Project	IEEE 802.16 Broadband Wireless Access Working Group < http://ieee802.org/16 >	
Title	Control Channel FEC parameter change	
Date Submitted	2001-01-16	
Source(s)	Alok Gupta Ensemble Communications, Inc. 9890 Towne Centre Dr. San Diego, 92121 USA	Voice: (858) 458 1400 ext. 133 mailto: alok@ensemblecom.com
Re:	This document is intended for discussion on PHY comments regarding a requested change in the RS block size of the control channel FEC	
Abstract	See above	
Purpose	See above	
Notice	This document has been prepared to assist IEEE 802.16. It is offered as a basis for discussion and is not binding on the contributing individual(s) or organization(s). The material in this document is subject to change in form and content after further study. The contributor(s) reserve(s) the right to add, amend or withdraw material contained herein.	
Release	The contributor grants a free, irrevocable license to the IEEE to incorporate text contained in this contribution, and any modifications thereof, in the creation of an IEEE Standards publication; to copyright in the IEEE's name any IEEE Standards publication even though it may include portions of this contribution; and at the IEEE's sole d

Figure 01. Modem and FEC Decoding Delay for the Maps

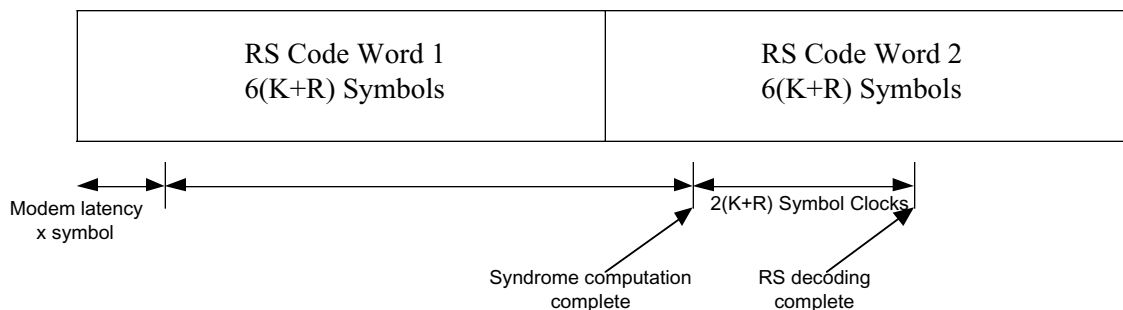
The downlink map contains pointers to the start of the different modulation fields for the same frame. It is necessary to have the first decoded pointer available before the corresponding data field begins. Assuming symbol clock is used for the RS decoder, the delay through the decoder for a (K+R,K) RS code is $2(R+K)$ symbol clock cycles (R cycles for Euclidean or Berlekamp algorithm, K+R cycles for Chien search and error value computation and K cycles for transferring the corrected message bytes). The (K+R,K) RS code word block with (24,16) inner code and QPSK modulation has duration of $1.5 \cdot 8 \cdot (K+R)/2$ symbol clock cycles. We also need to account for the modem latency. Let us assume the modem latency is x symbols. Then as long as there are at least two RS code words containing the maps and $2(R+K)+x < 6(R+K)$, we are guaranteed to have the information in first RS code words decoded and available for use before the data field begins. The following diagram summarizes the delay calculations.

Thus for Modem and FEC decoding latency reasons as well as for the worst case scenario of having only two RS code words containing the maps, it is necessary that at least the first pointer is part of the first RS codeword.

Thus it is obvious that 20 bytes of message length is not sufficient to accommodate the first pointer in the first RS codeword and a minimum of 26 bytes is required. We propose to change the outer code specification to a (46,26) code.
